Exhibit 1:
August 7, 1990, 55 FR 32137, Sole Source Aquifer Designation for the
***Plymouth-Carver Aquifer*, Massachusetts, U.S. Environmental**
Protection Agency.

May, 2021, *Comment Letter on MEPA #13940 Environmental Notification Form for Three AD Makepeace-Borrogo LGMSI in Wareham*, prepared by Partnership for Policy Integrity.

Figure 1. Global Forest Watch overview of forest loss in the area of the project. The three proposed solar fields are marked with black dots.

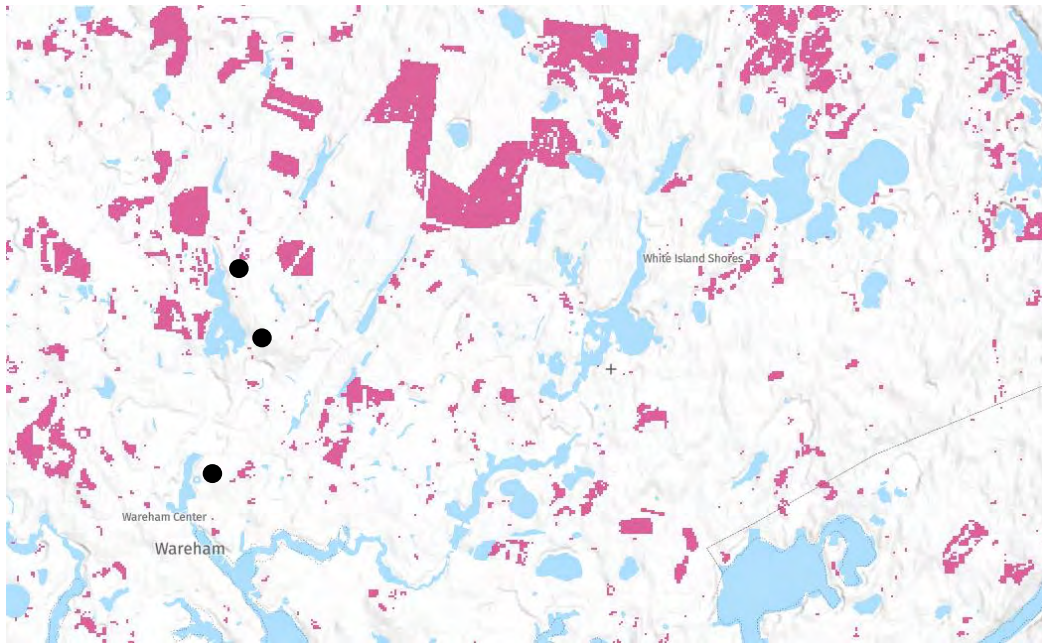
Satellite imagery from Global Forest Watch shows that forest loss in the vicinity of the project is particularly high. Figure 1 shows forest loss just since 2000¹; it doesn’t even include the large amount of conversion to cranberry bogs and other uses from before 2000. In fact, pulling back, this area appears to have one of the highest rates of forest loss since 2000 in the entire state of Massachusetts.

We wonder if the program would use similar language today. There is no “net” benefit given the accelerating forest loss in the region, as shown in Figure 1.

Figure 3. The graph of the relationship between diameter and area (square meters) overlaid on the proponents’ graph of diameter and volume (cubic meters) translated in some unknown way to weight of biomass.

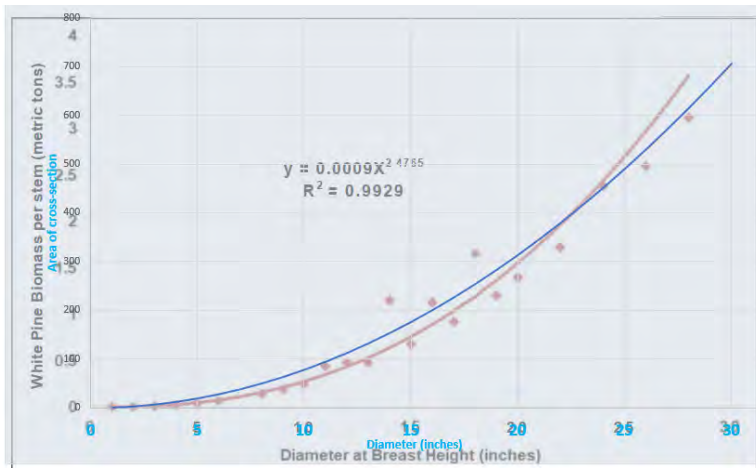
Given this failure and the proponents’ evident unfamiliarity with protocols for ecosystem carbon assessment, we have no confidence in the approach to calculating increased DBH and volume through time, which uses a “simplified, linear growth rate formula.” They do cite a reference for this approach, but it is not clear if their analysis of forest biomass takes into account the fact that trees with bigger circumference tend to also be taller, meaning their overall volume is greater. In fact, the regression curve that proponents provide for volume/weight (cubic meters) looks very similar to a standard curve of the relationship between diameter and area of a cross-section of a tree (square meters), which if the trunk is circular in cross-section would follow the relationship of “pi-r-squared.” We graphed up that simple relationship (in blue) and overlaid it on the on the proponents’ graph (Figure 3):

It appears that the proponents’ analysis of biomass per stem does not correctly reflect the overall increase in volume, because it traces a relationship of DBH to stem cross-sectional area, rather than full tree volume. Further, a stem analysis does not really tell much about forest biomass as a whole, unless there is a detailed count of stems per acre, and the analysis includes the volume of stumps and roots. Even with that information, the analysis of carbon *stocks* is incomplete, because it does not include soil carbon. For an analysis of future sequestration (carbon sinks), however, soil carbon may be difficult to quantify.
